MODIFICATION SHEET No. WAM4/IB

Provision of current differential wheel slip relay QD.

PROVISION OF QD RELAY
IN ACMT LOCOS (WAM4)

WAM-4 FDSO SKILL 2173

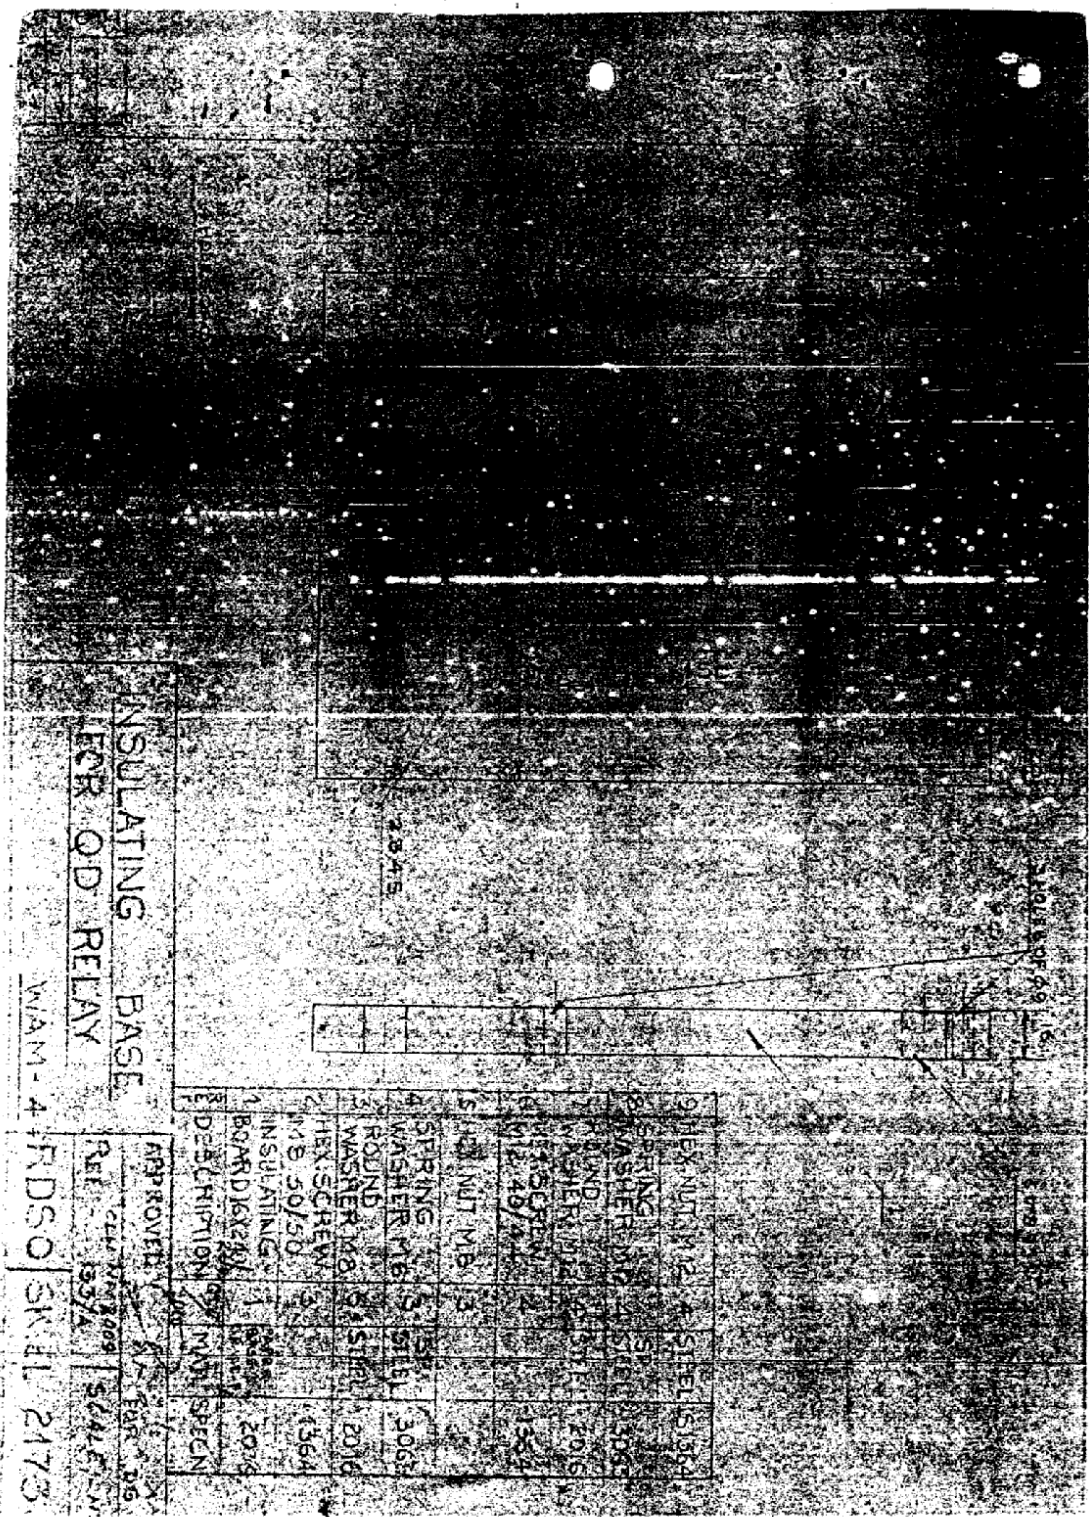
INSULATING BASE
FOR OD RELAY

Existing voltage differential relay is to be removed and a current differential relay type CR 201 or M/S Alsthon make is to be provided in 8A2 panel as a replacement.

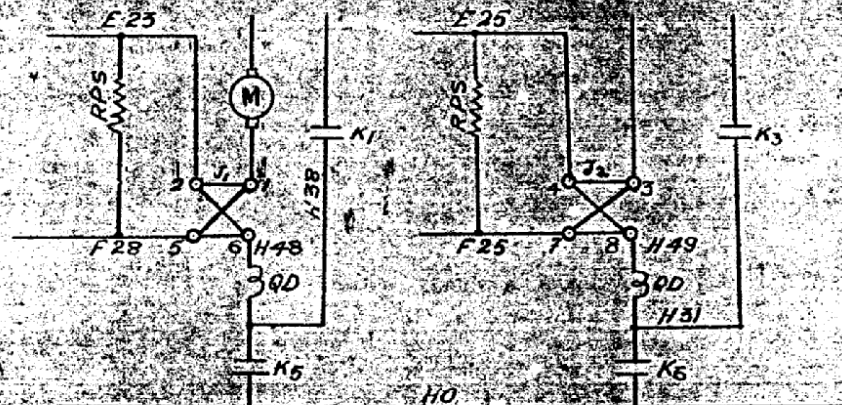
EXISTING

MODIFIED
